from
**Southern
Water**

Our ref
DSA000011954

Proposal: Erection of 1 No detached dwelling and garage with shared access from Maypole Lane. This application is a Departure from the Development Plan, and this site is in CIL Zone 3 and is CIL Liable as a new dwelling.

Site: Y/60/22/PL: - Longacre, Maypole Lane, Yapton, BN18 0DR.

Southern Water MapGuide Browser

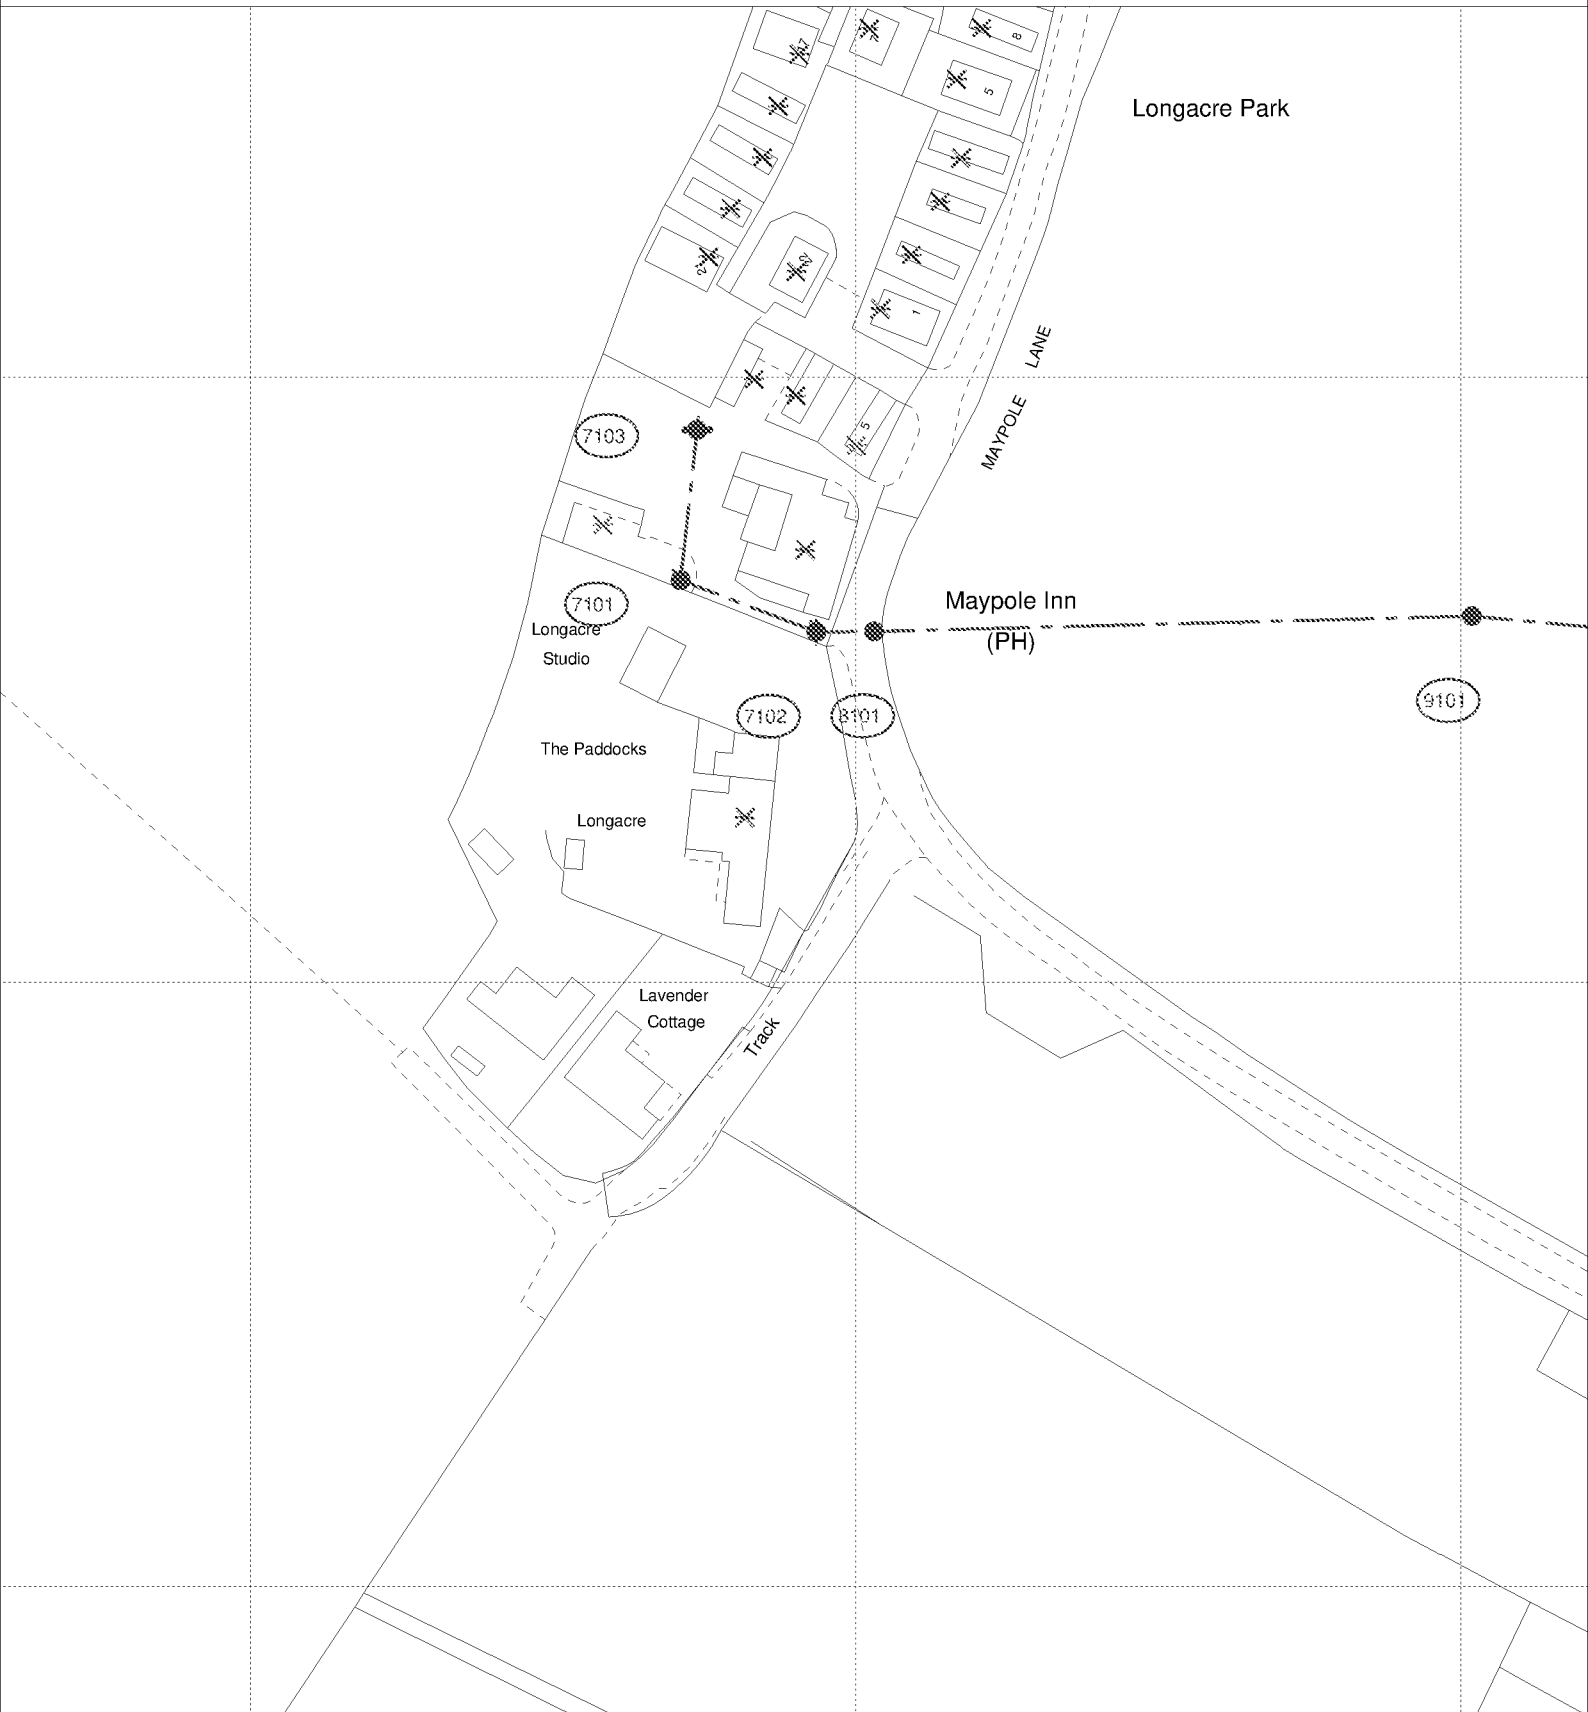
It is possible that a sewer now deemed to be public could be crossing the development site. Therefore, should any sewer be found during construction works, an investigation of the sewer will be required to ascertain its ownership before any further works commence on site.
